In the Matter of an application for Private Plan Change 82 (**PC82**) by **MOONLIGHT HEIGHTS LIMITED** to rezone 39.2 ha of land at Awakino Road, Dargaville from Rural Zone to Residential Zone

Evidence of Nathaniel Jull on behalf of Moonlight Heights Limited

(Civil Engineering – Three Waters)

Dated 21 July 2023

Figure 1: Flood Susceptibility Map Based on Current NRC Flood Data

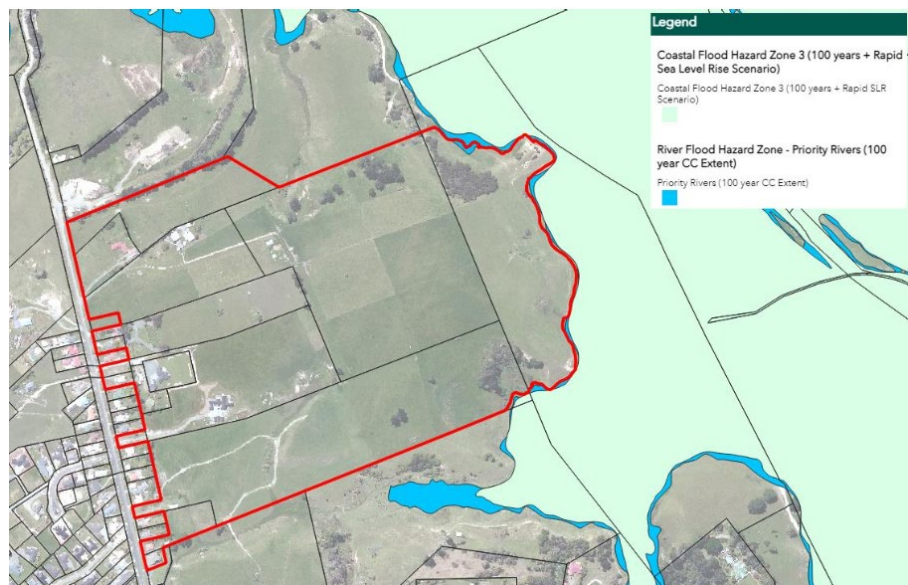
34. The Section 42A Report has identified the PC82 area as being an *'Area Susceptible to Flooding'*. This is based on the Flood Hazards Overlay mapping of the Operative Kaipara District Plan and shown in point 30 (Figure 10) of the Section 42A report.

35. The mapping referenced in the Section 42A Report is from the Operative Kaipara District Plan Appendix C and uses flood data provided by the Northland Regional Council (NRC) in 2008. Since then, further flood modelling has been completed by the NRC and the mapping refined. Figure 1 below shows the PC82 area against the latest NRC flood mapping.

36. As shown in Figure 1 above the site is outside the area identified as being susceptible to River and Coastal Flooding.
